**ADDENDUM #1
RESPONSE TO QUESTIONS
Liberty Hills Sanitary Sewer Rehabilitation Project**

VILLAGE OF POWELL, OHIO
 SANITARY PLAN & PROFILES
 FOR
**FALCON RIDGE
 SECTION 1**

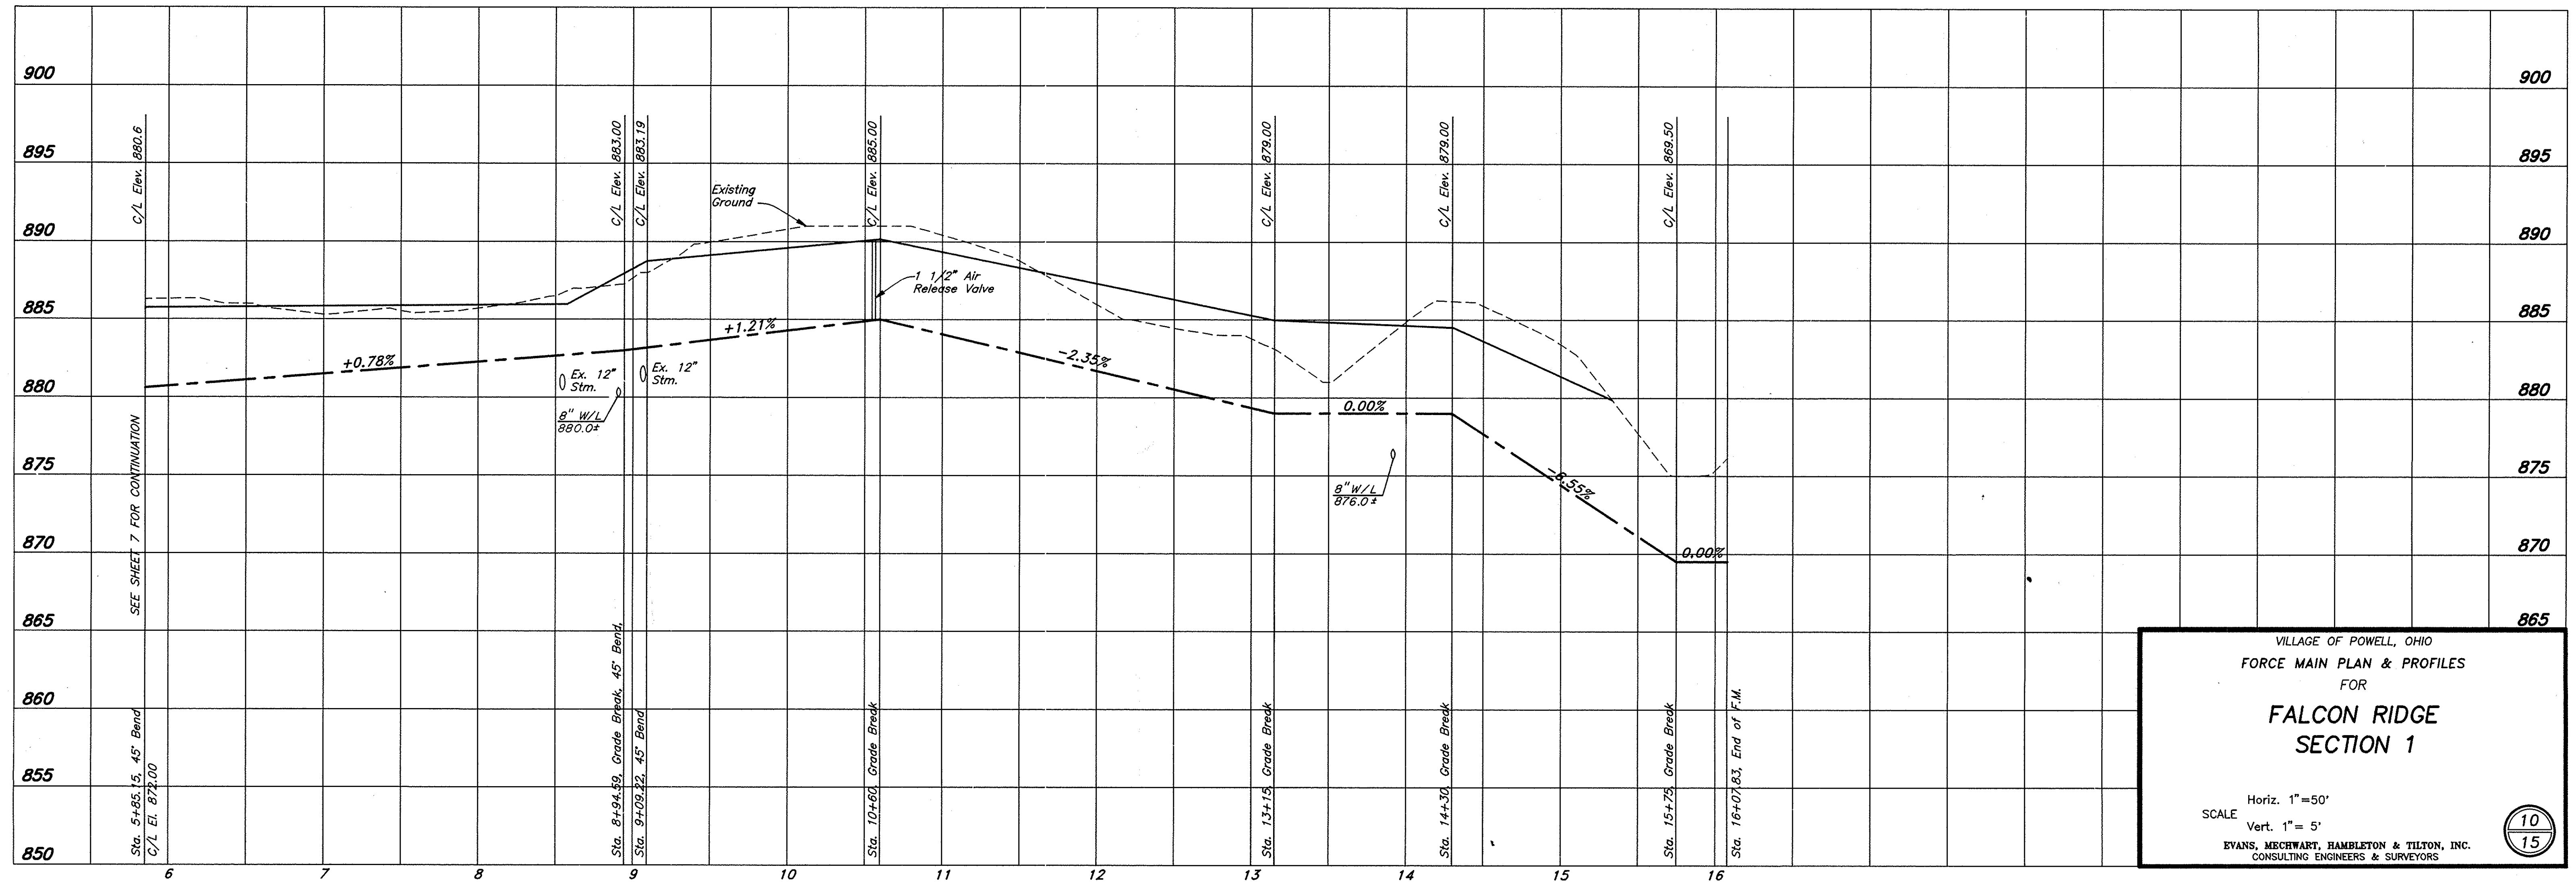
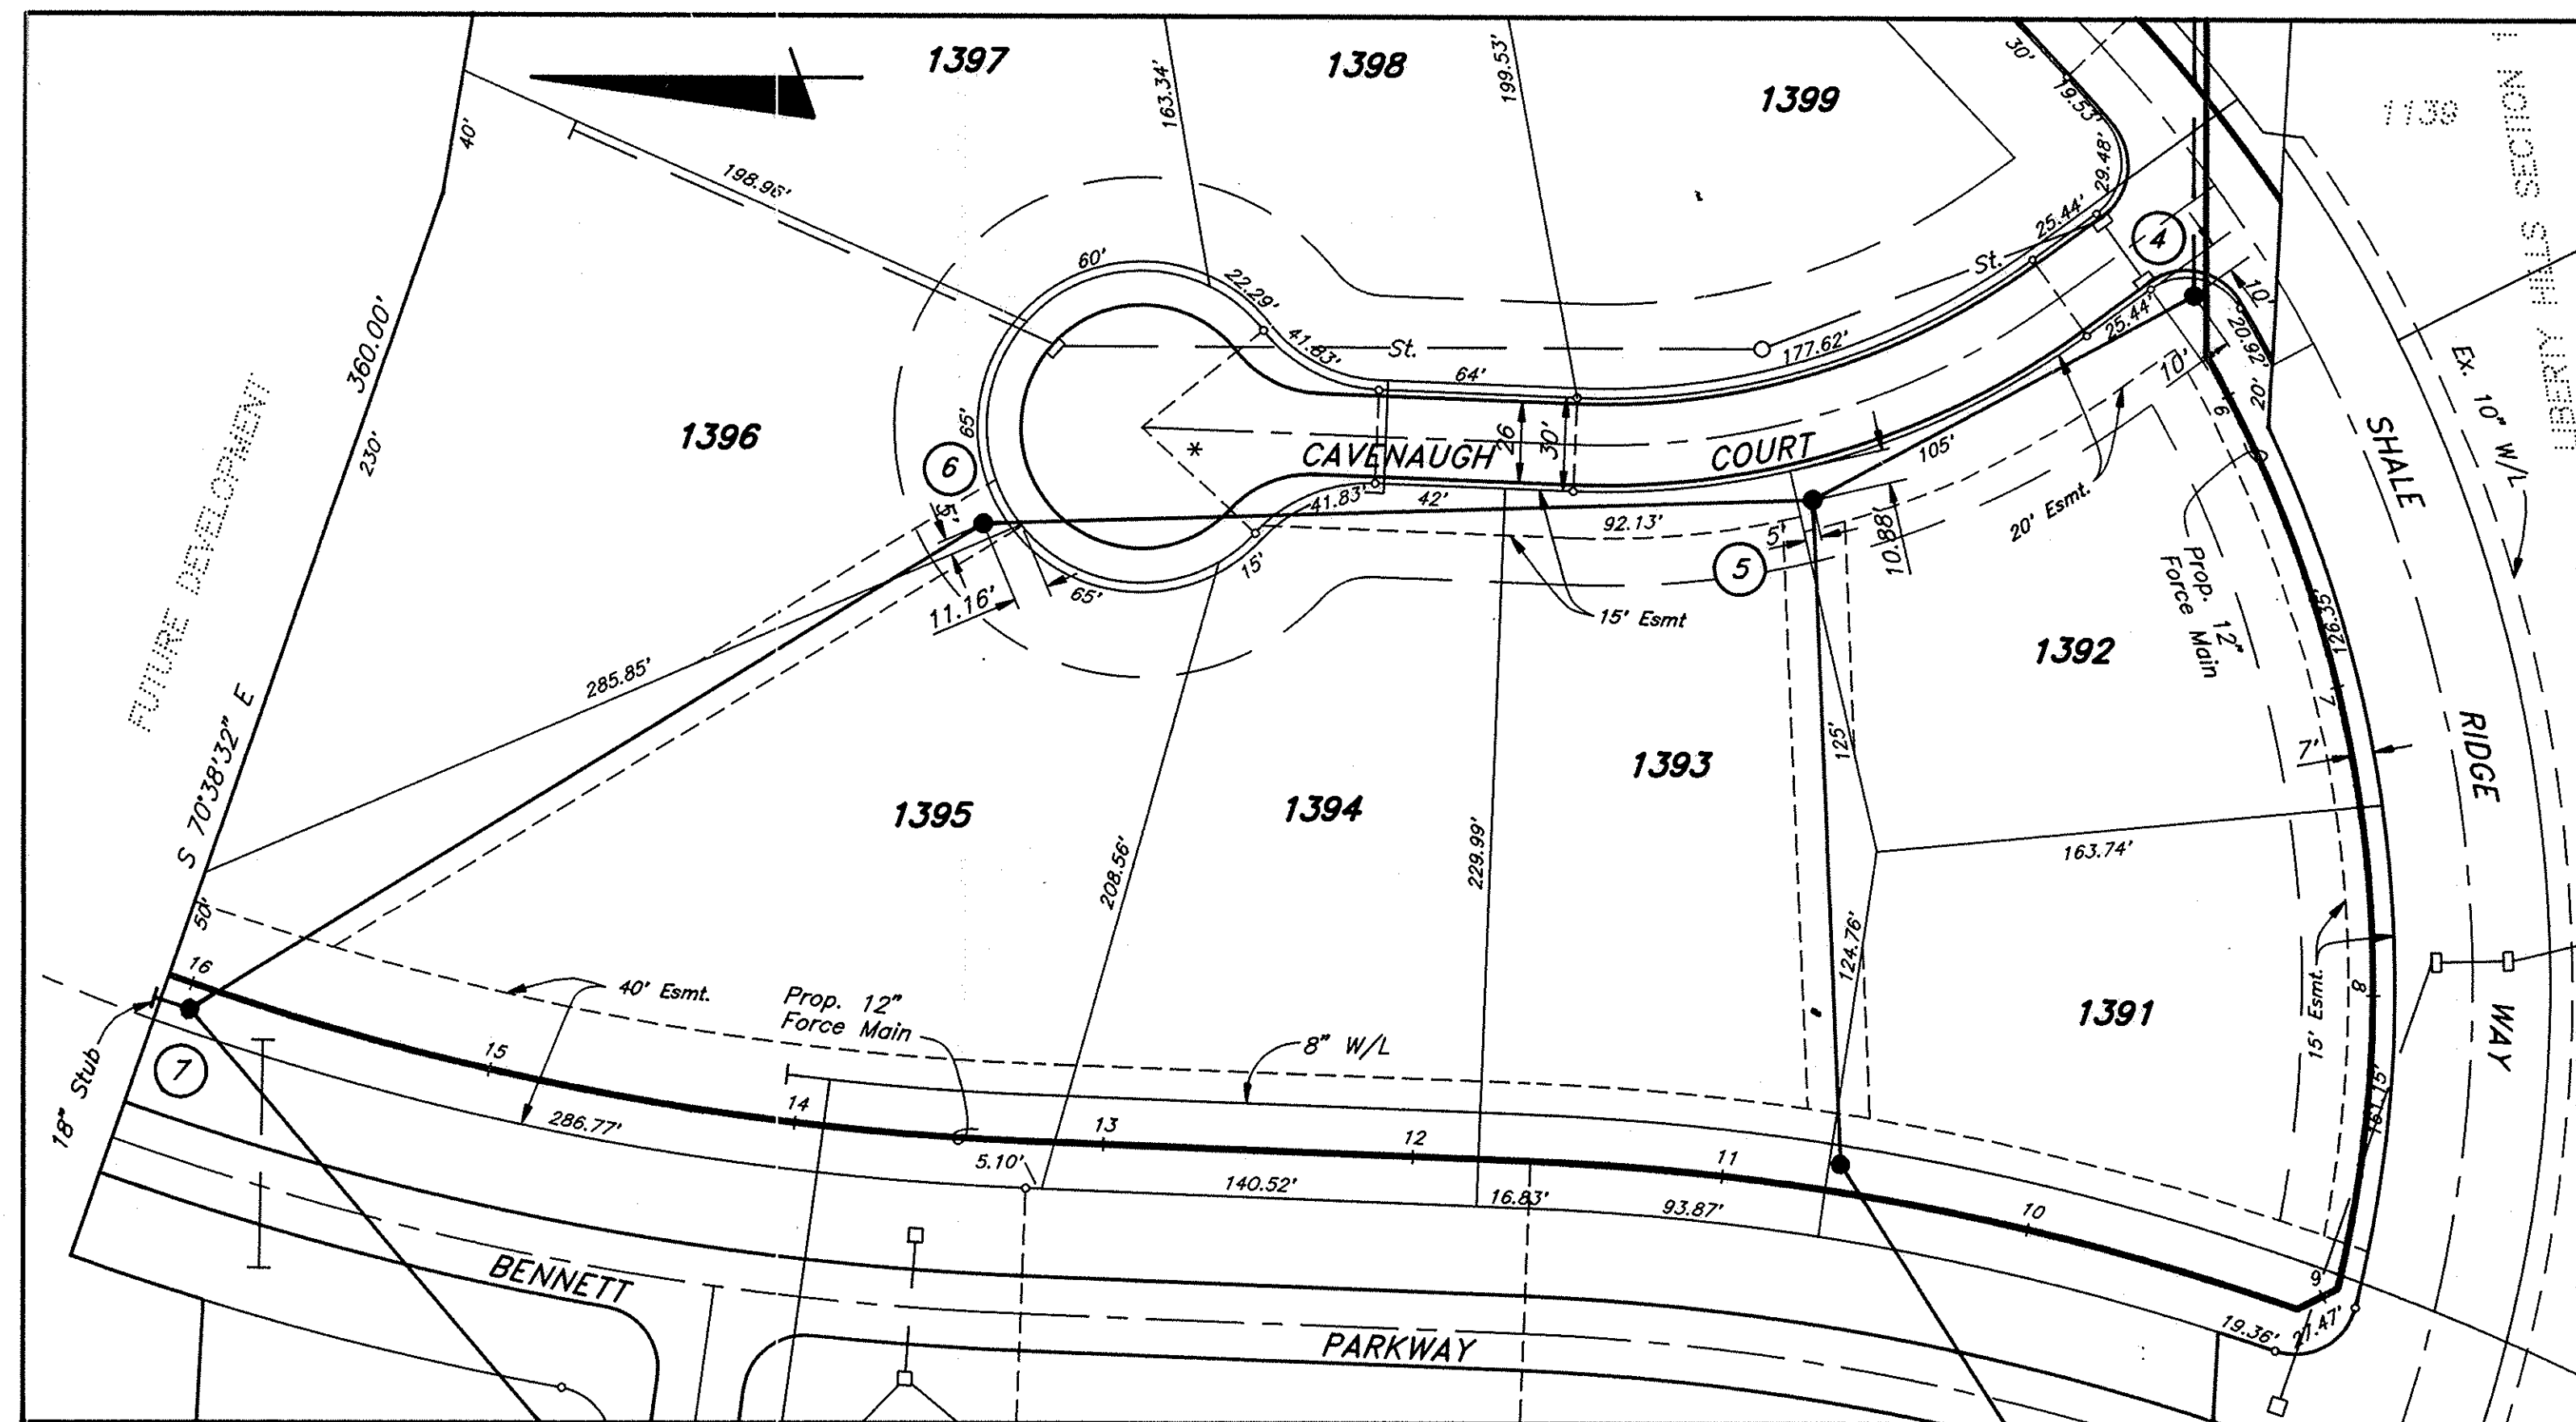
3. Can record plans for the 18" Falcon Ridge Section 4 tie-in to MH 01 be provided?

YES – SEE ATTACHMENT 1 TO THIS RESPONSE TO QUESTIONS.
